Subject: Submittal of Supplemental Information for the MAGNASTOR System
Application (TAC No. L23764)

Docket No. 72-1031

List of Drawing Changes for the MAGNASTOR Storage System, Revision 06A

Drawing 71160-585, Revision 4 – TSC Assembly, MAGNASTOR

Figure 4.8.2-2 Three-Dimensional Fluent Model of a Fuel Assembly Grid

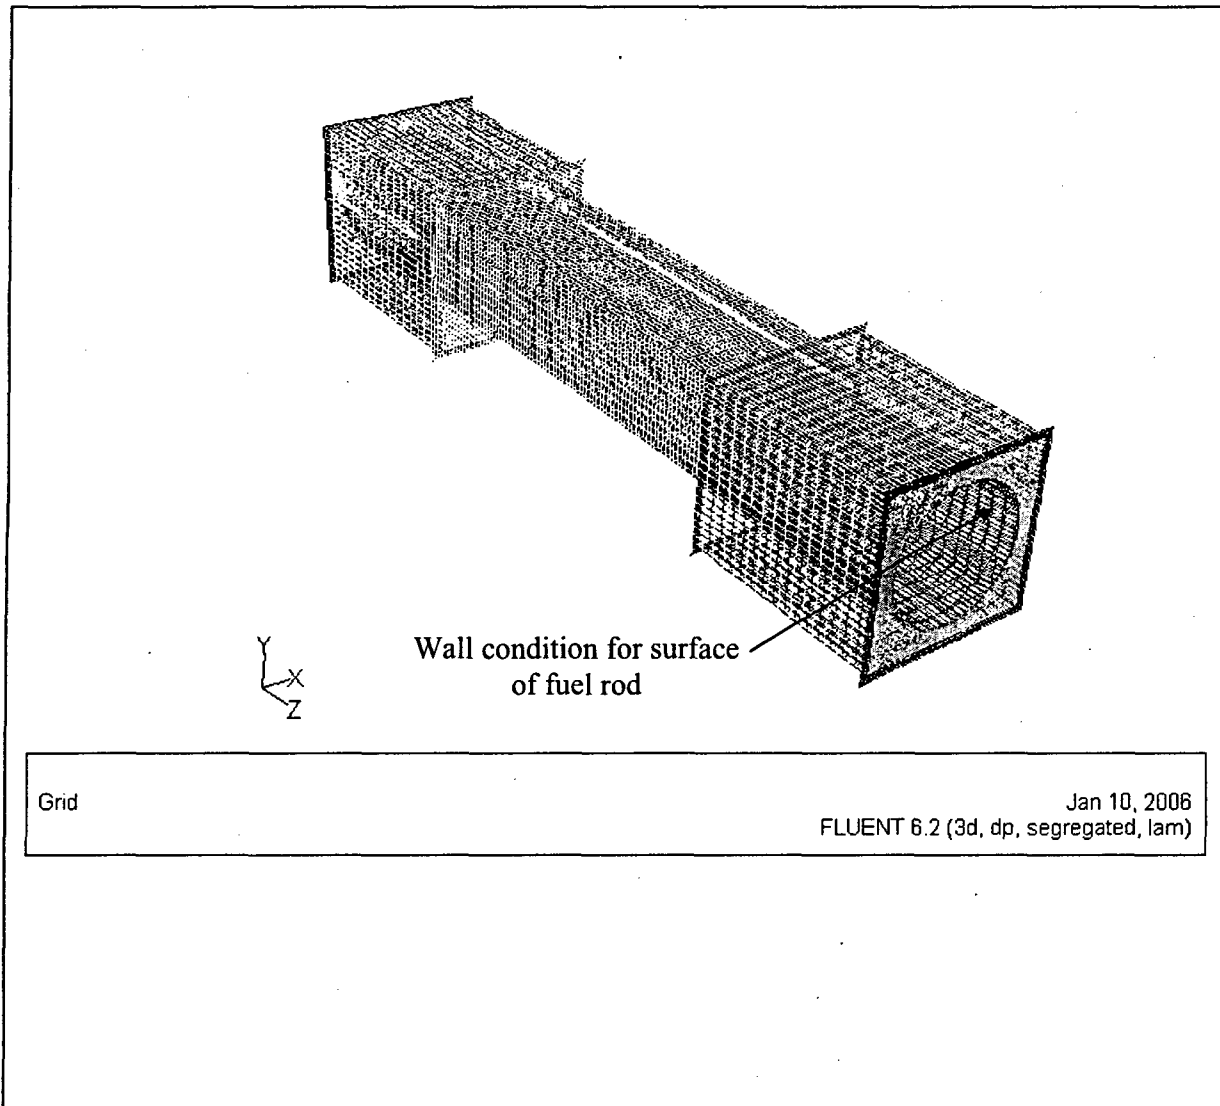
Page 4.8.2-3	Paragraph below 1 st equation – added new 1 st sentence (i.e., “The pressure drop ... set to zero.”); 2 nd sentence – changed “eight grids” to “all the grids” & deleted the 2 nd “eight”; 2 nd equation – changed “4.64e5” to “462,087”
Page 4.8.2-4	Paragraph revised throughout
Page 4.8.2-6, Figure 4.8.2-2	Inserted revised figure
Page 4.8.2-7, Figure 4.8.2-3	Inserted revised figure
